**Subject: Genesis Solar, LLC's Petition for Genesis Solar Energy Project  
Docket No. (09-AFC- 8)**

# **Genesis Solar Energy Project Eastern Riverside County, California**

## **Amendment (09-AFC-08)**

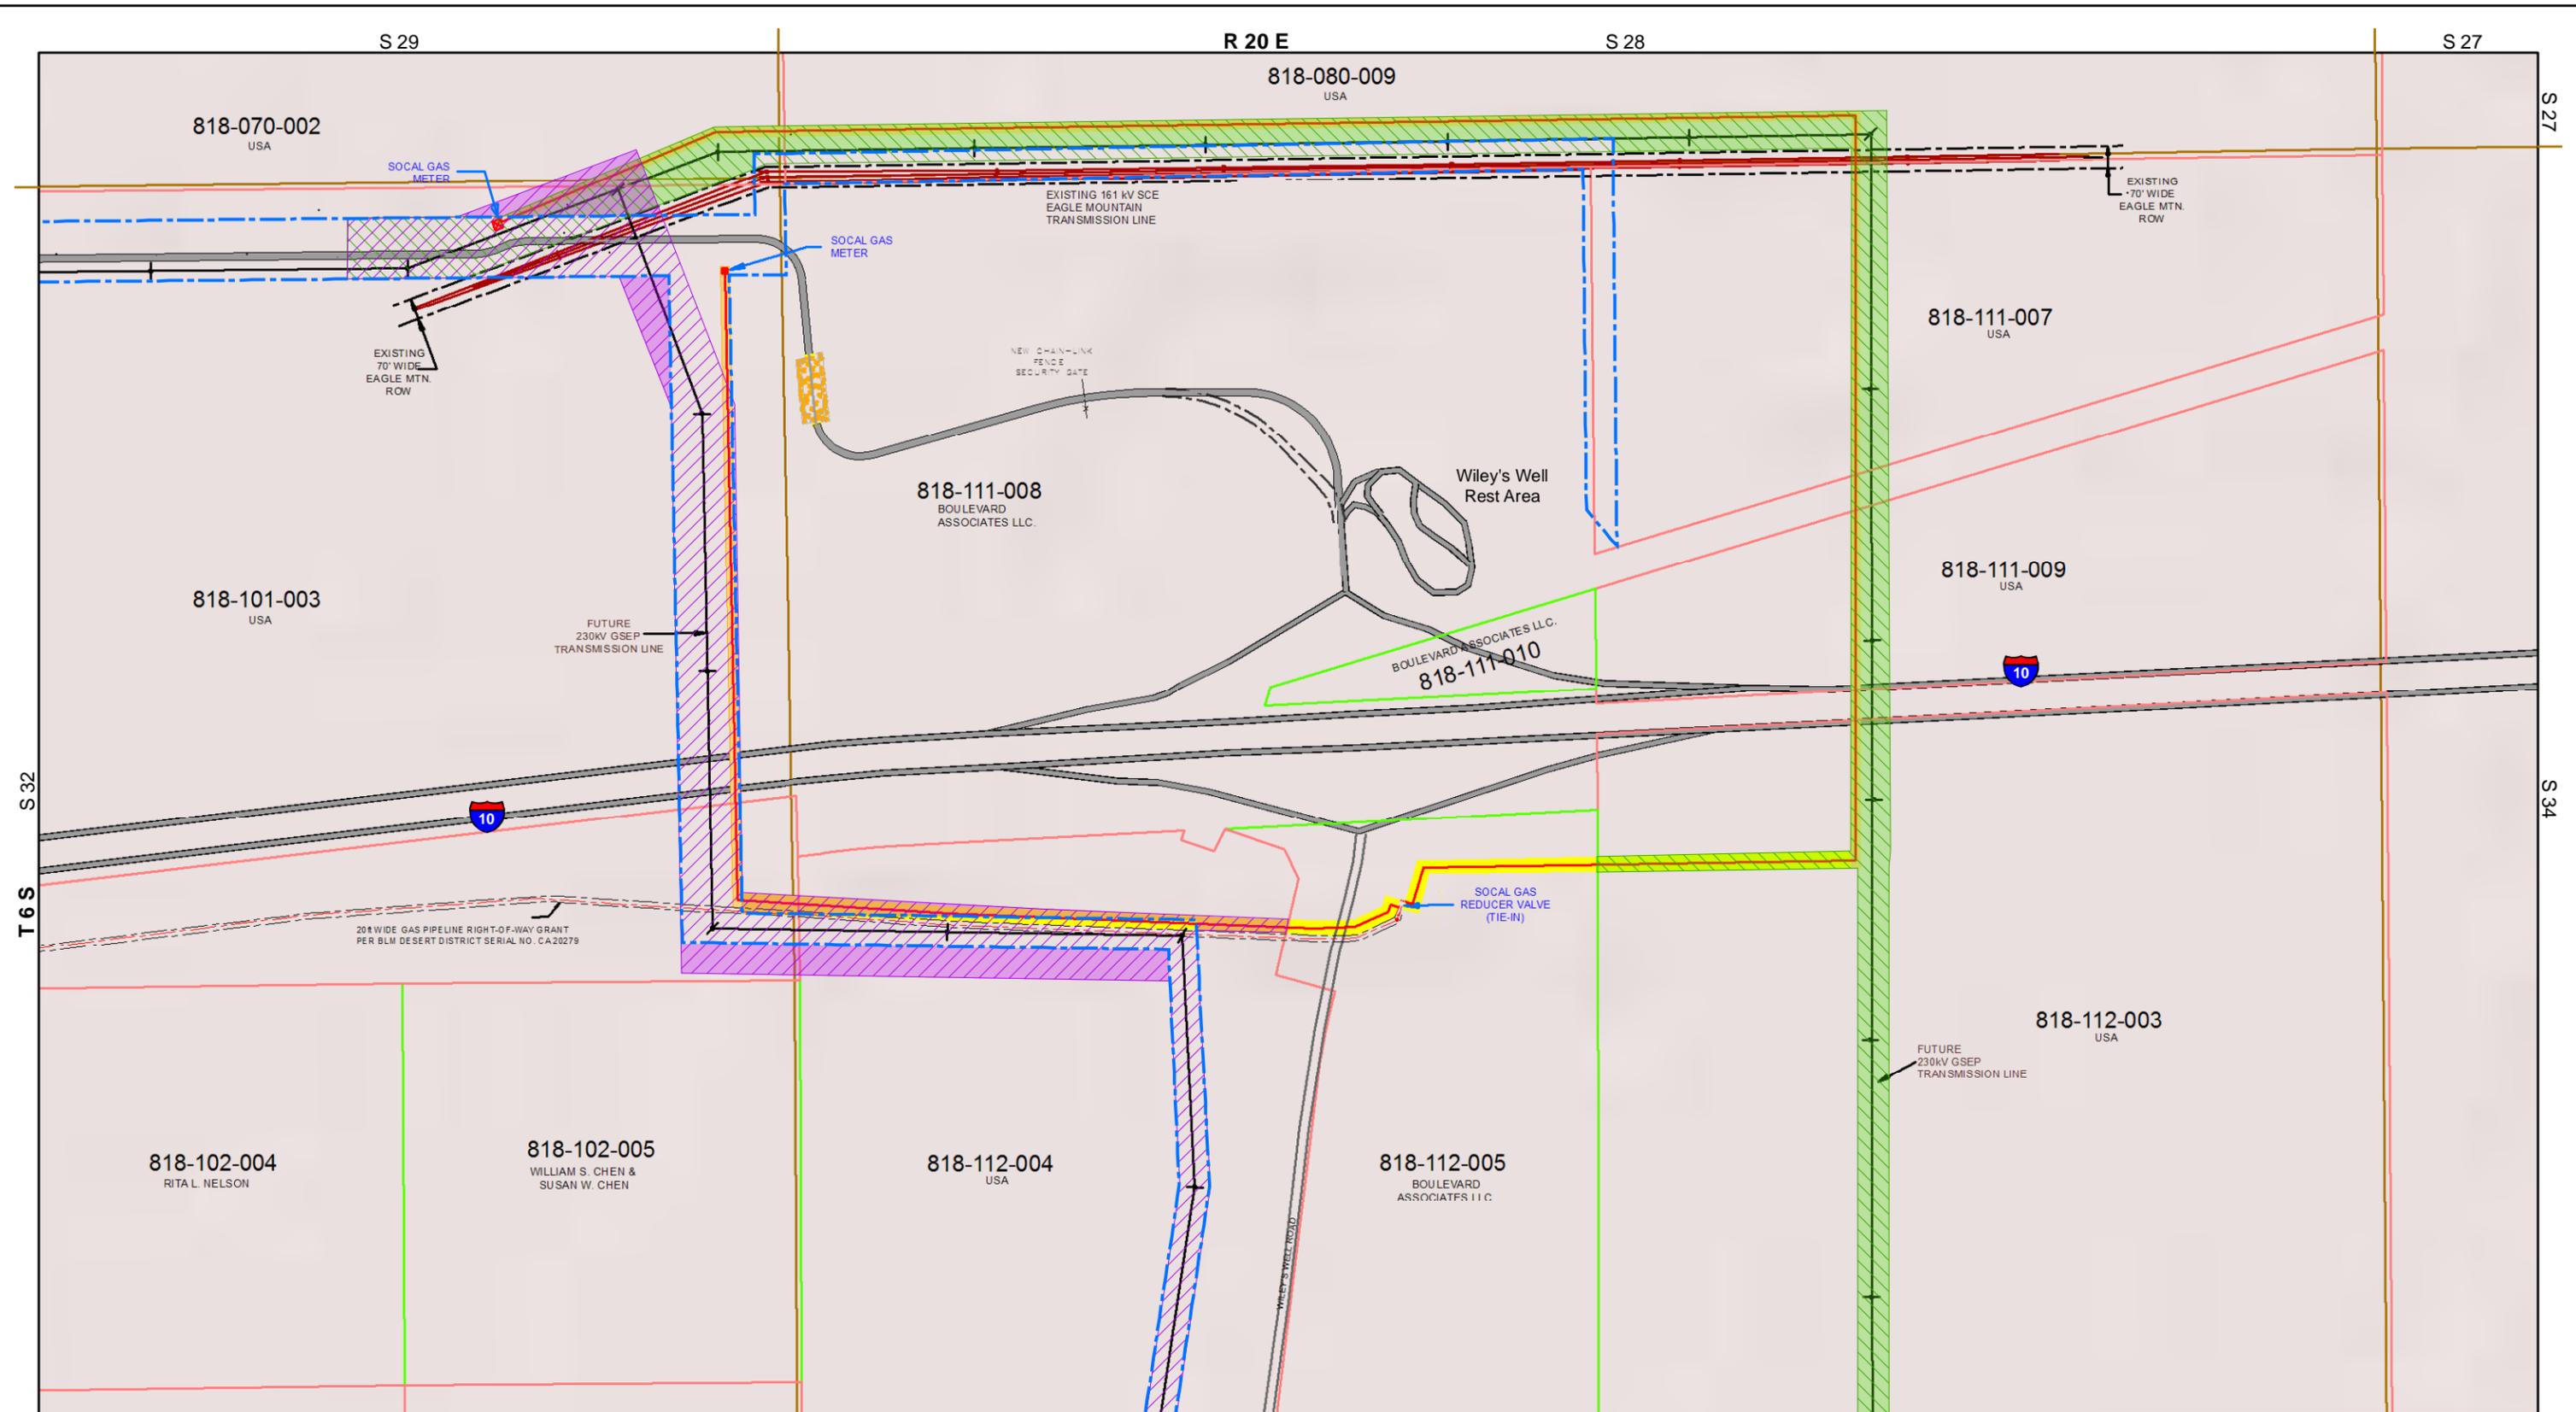
This option is the permitted gen-tie route currently in the CEC Final decision and BLM ROW; however, changes are needed to the ROW to allow the gen-tie to cross the SCE Eagle Mountain 160 kV line and tie into the BETL. Figure 2, View 1 shows the modifications to the ROW necessary to cross the Eagle-Mountain line. SCE requires that non-SCE transmission lines cross their system lines at a 90 degree angle (i.e. perpendicular). The presently-approved ROW does not provide sufficient room to facilitate that crossing. The approved gen-tie route in this area reflects a due-east path from the GSEP Plant Site until the gen-tie crosses over Eagle Mountain line at a 20 degree angle. The GSEP line then continues east within the approved ROW for approximately 540 ft. before turning due south within the approved ROW. The proposed gen-tie route also reflects a due-east path from the GSEP Plant Site to a point approximately 300 ft. west of Eagle Mountain Line. To cross the Eagle Mountain line at a perpendicular angle, the GSEP line will then need to turn east-northeast, paralleling the Blythe-Eagle Mountain line for approximately 675 ft., before turning south-southeast (perpendicular) for approximately 720 ft. to a point within the approved ROW. Two new turning structures will be required to cross the Eagle Mountain line at a perpendicular angle. The GSEP line will then continue south within the approved ROW.

**FIGURE 3  
OPTIONS A & B  
VIEW 2**

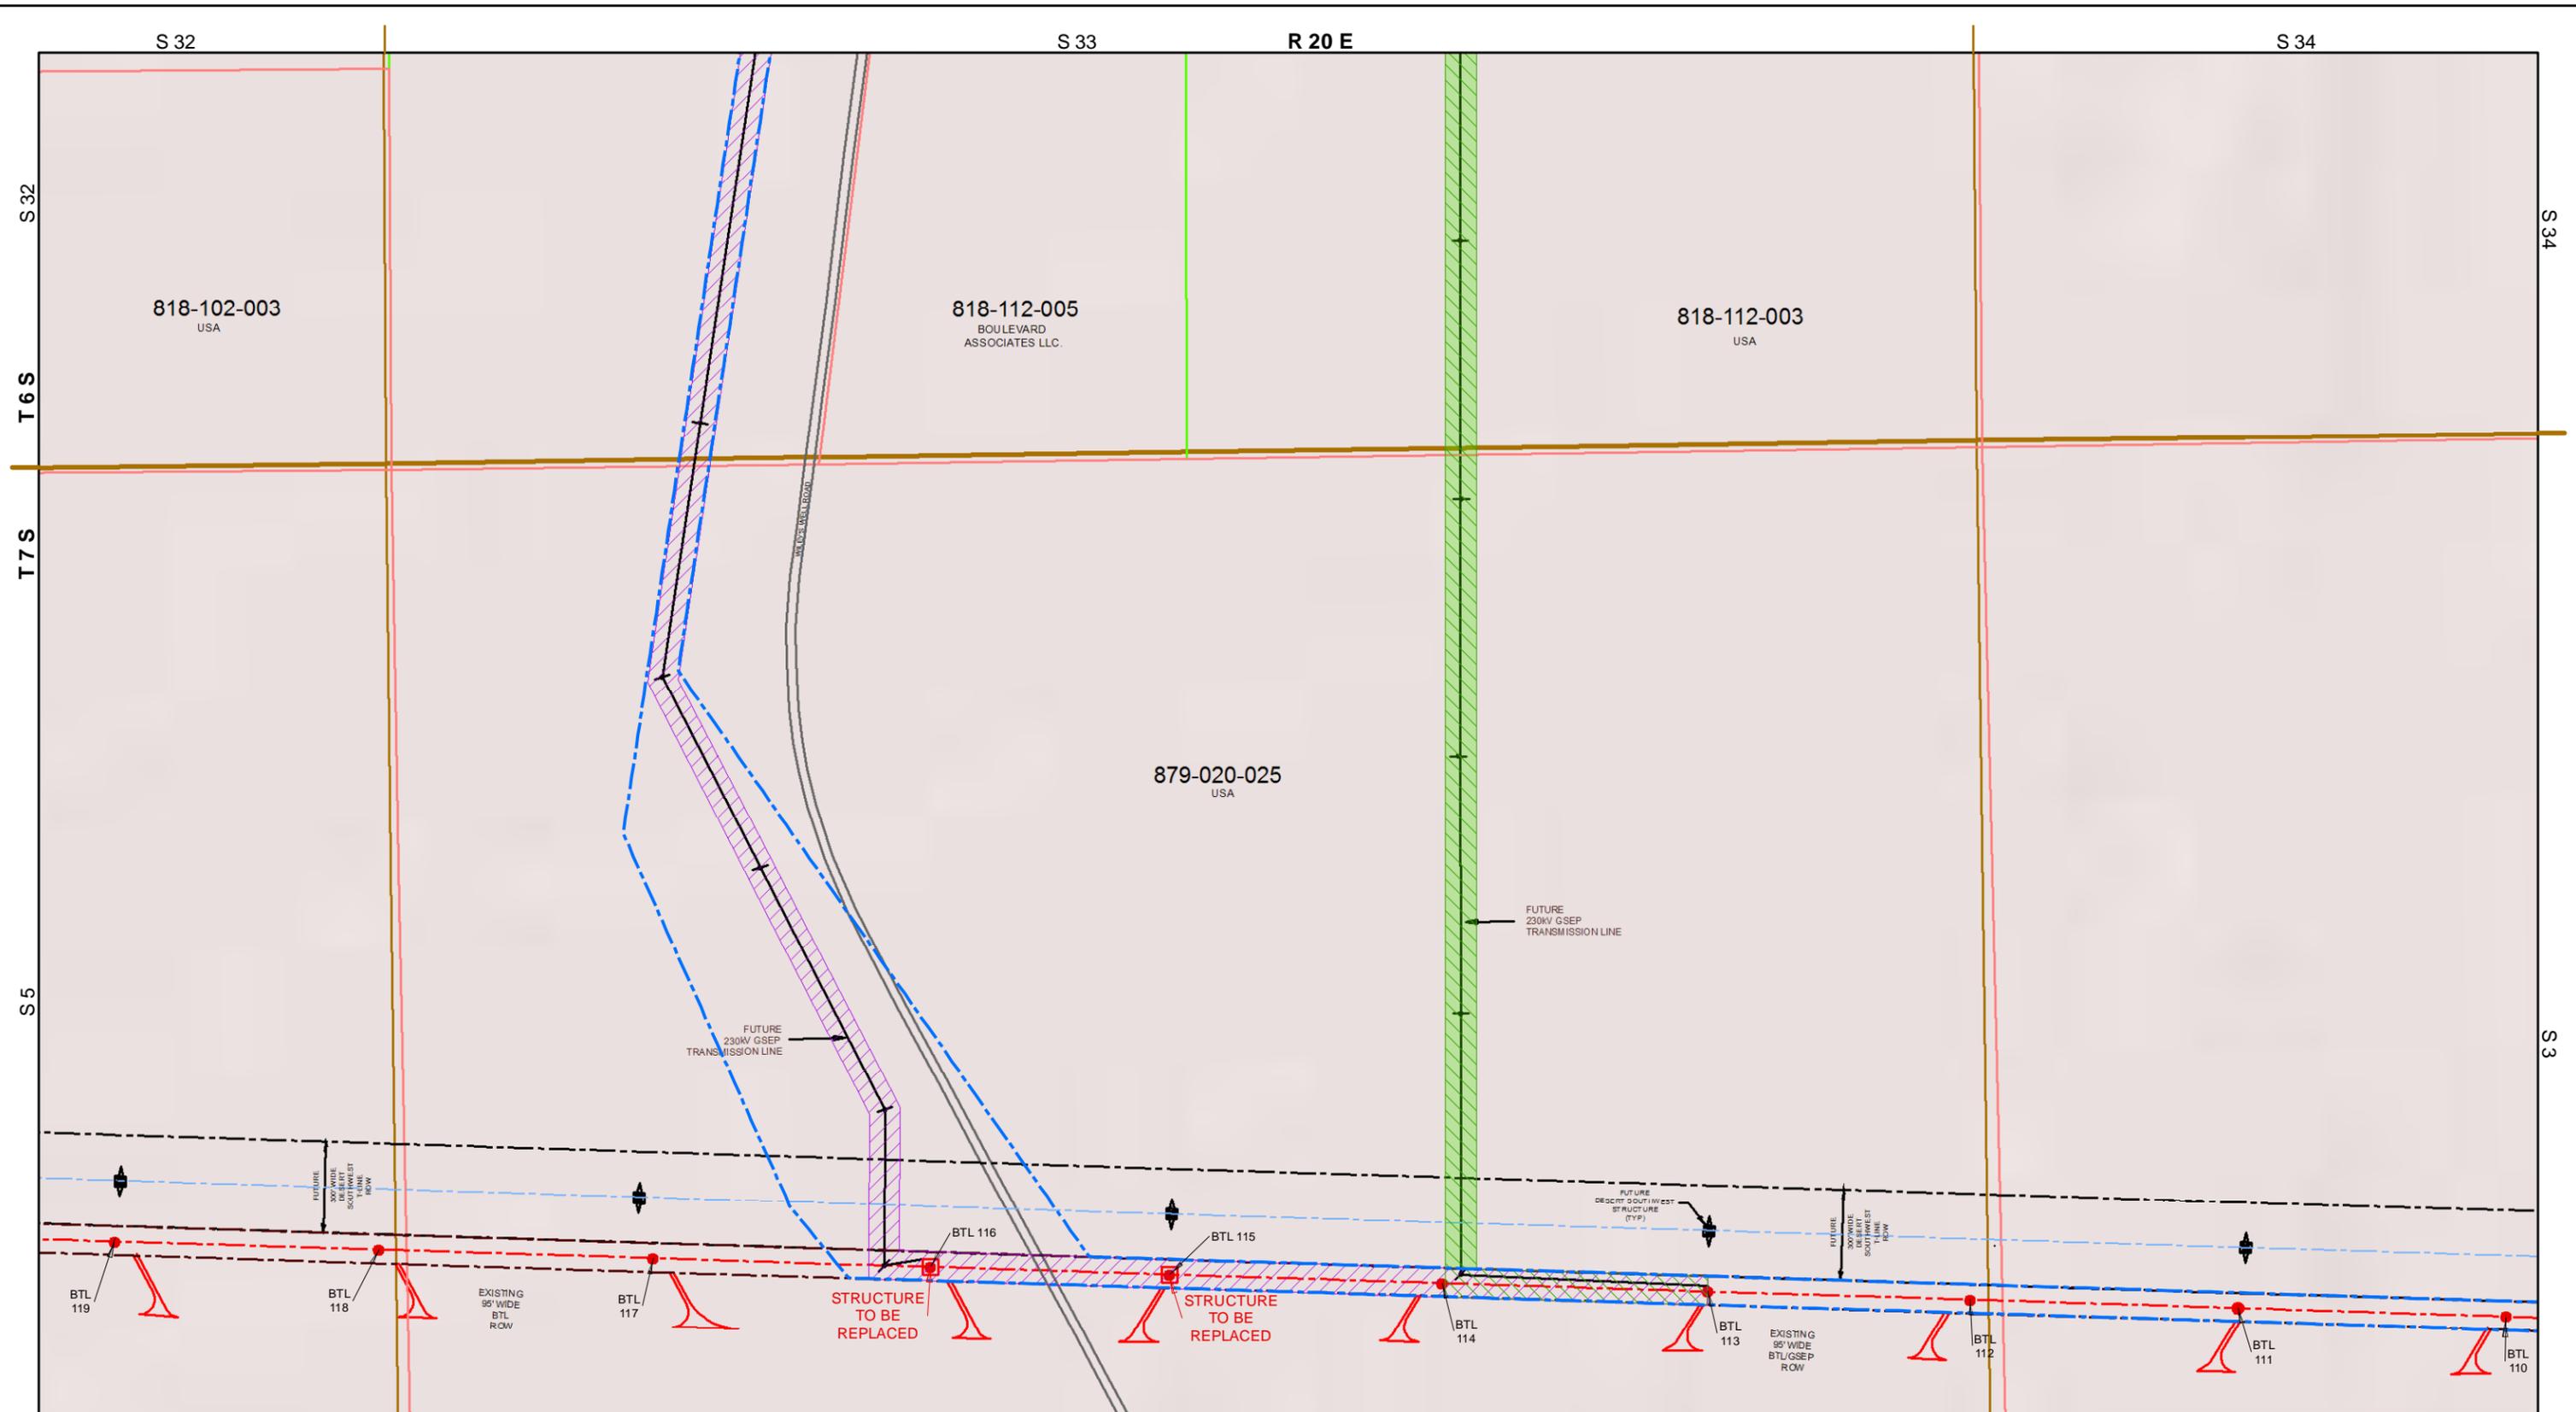
Figure 3, View 2 shows the location of the GSEP gen-tie entering the ROW of the BETL. One turning structure will be needed immediately north of the Desert Southwest ROW to span the future line and connect into BETL. A new pole will need to be added west of BETL pole number 116 to facilitate the connection of the GSEP line to BETL. Because BETL Poles 116 and 115

are currently single circuit, both poles will need to be exchanged for double circuit poles. BETL poles 114 through 88 are already double circuit and the GSEP tie-line will continue along these structures without any additional pole replacements. The GSEP tie-line will exit BETL at Pole 88 as described above in Section 3.1.

**FIGURE 4  
OPTIONS A & B  
VIEW 3**

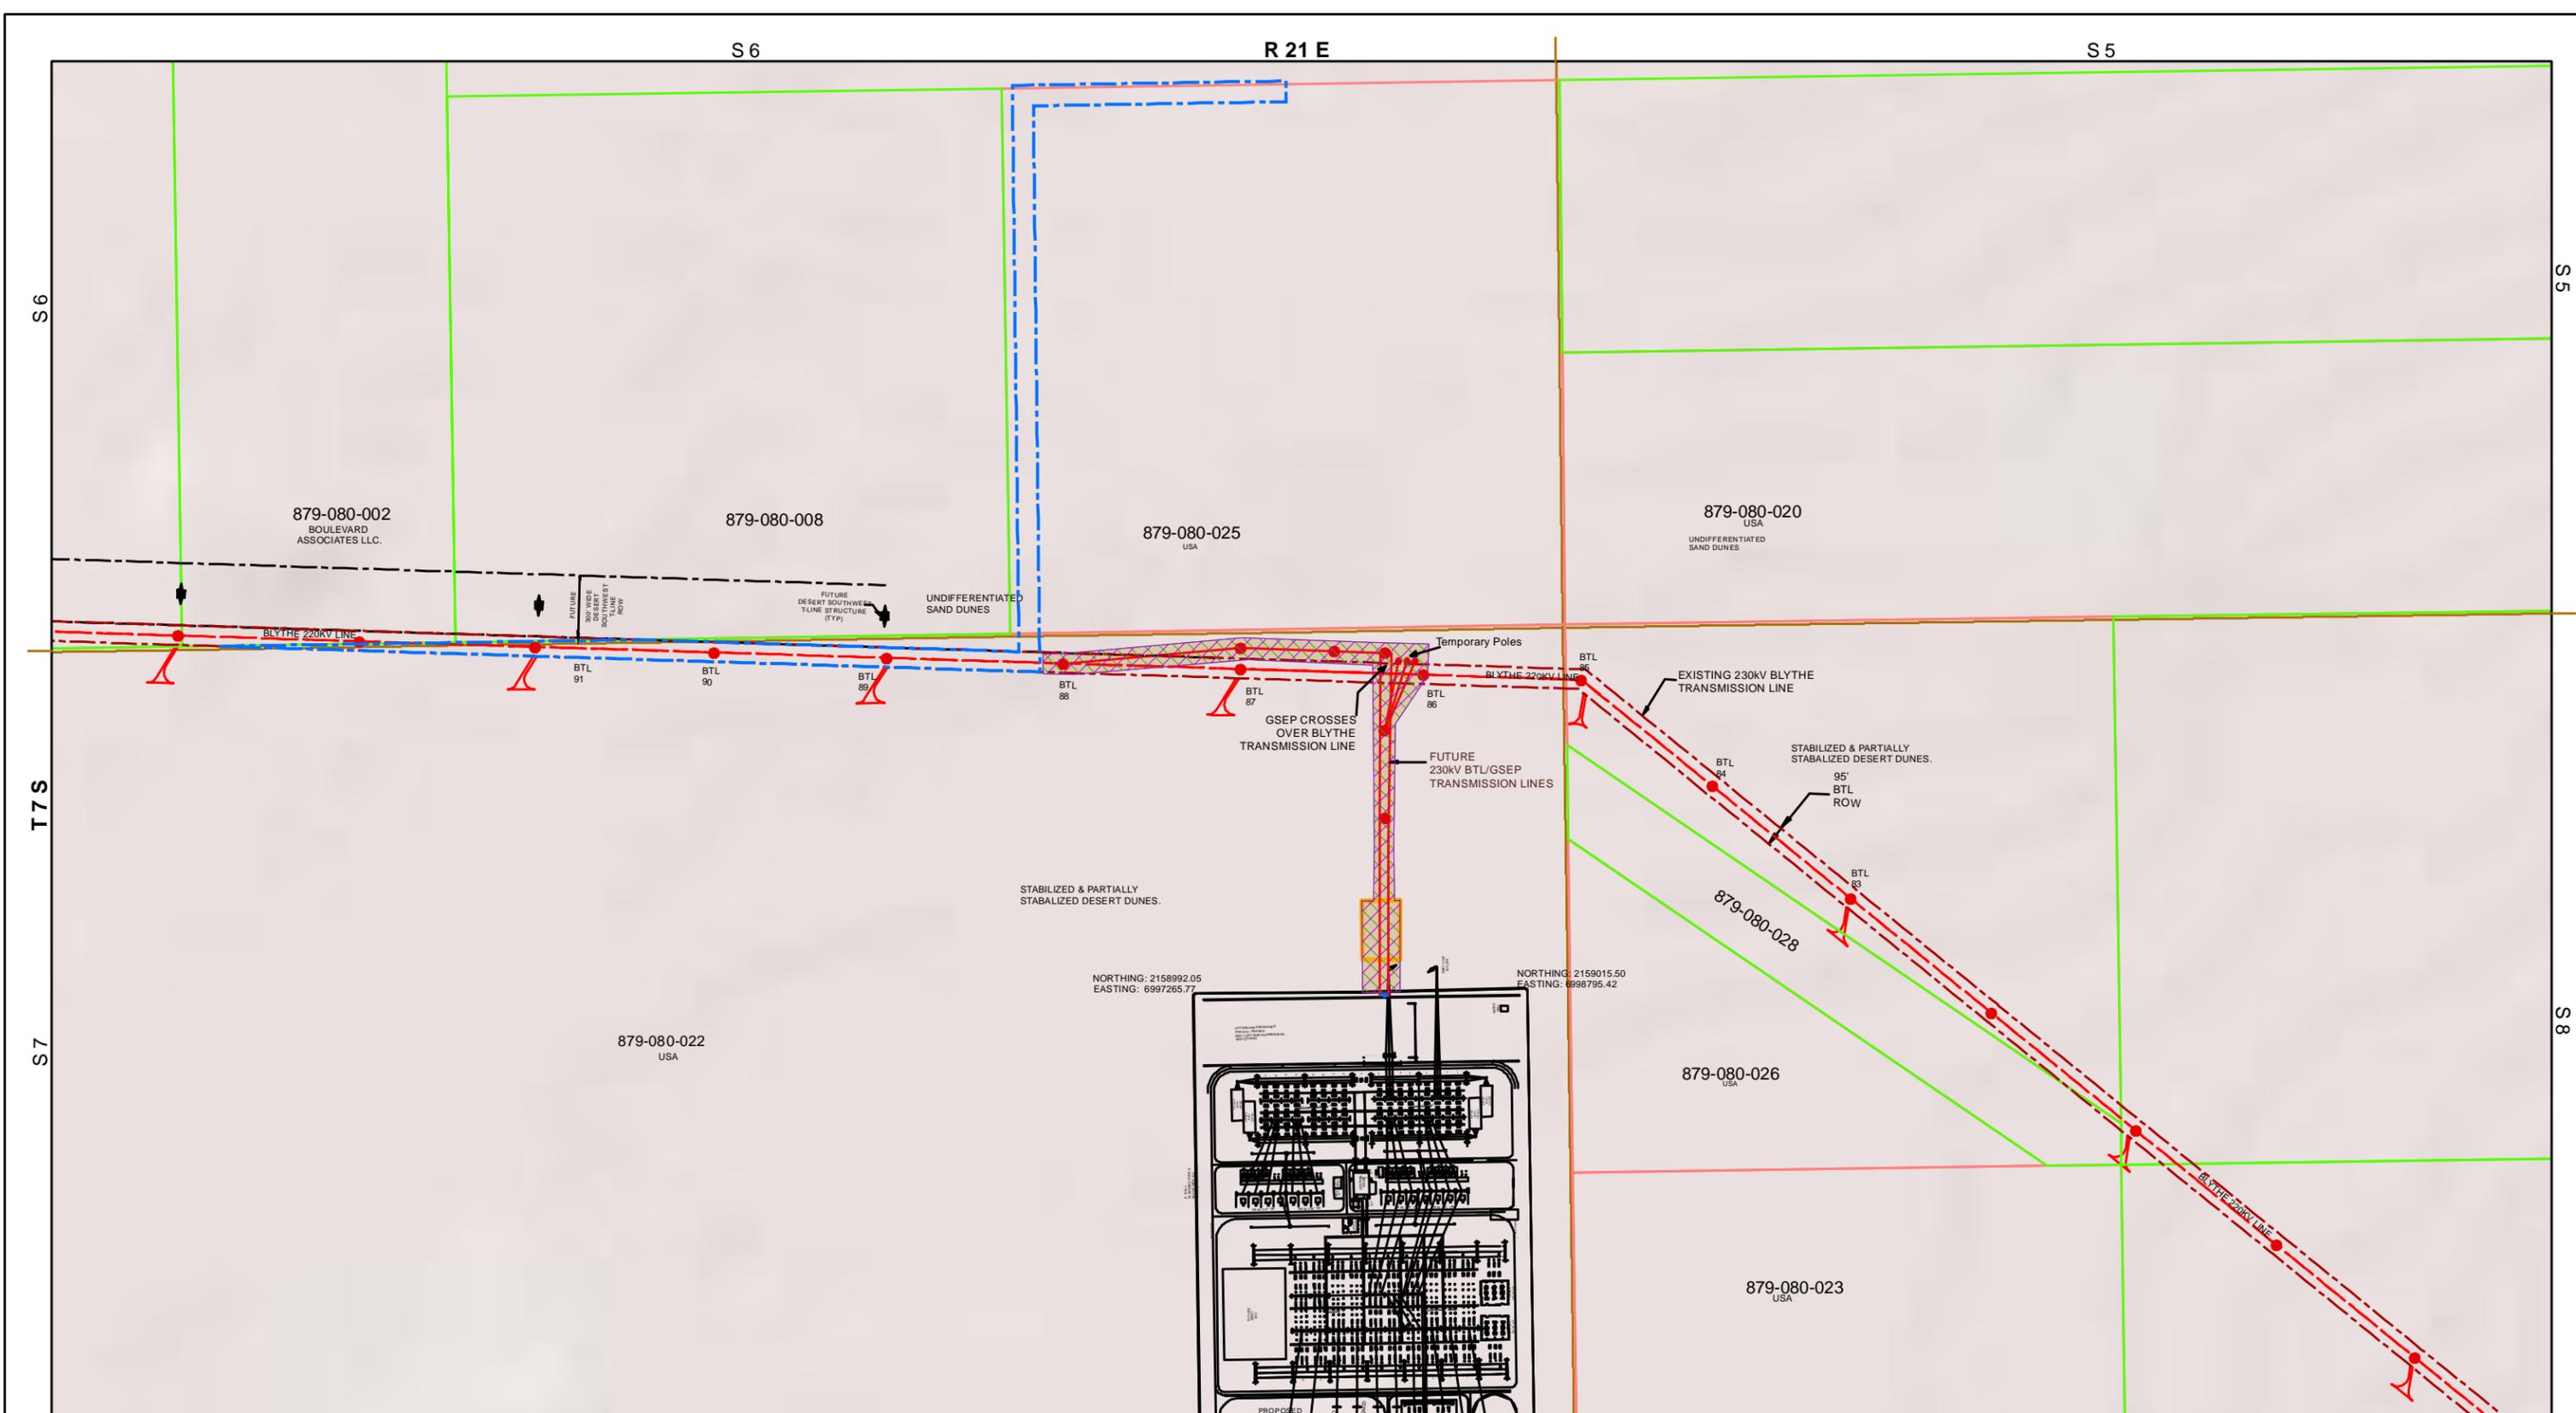
Option B will require some addition ROW to the north of the LS Power (formerly BETL) transmission line just before and after the 90 degree turn to the south towards the CRS (See Figure 4, View 3). This is the same configuration as Option A. Again, this area has been extensively surveyed for biological purposes.
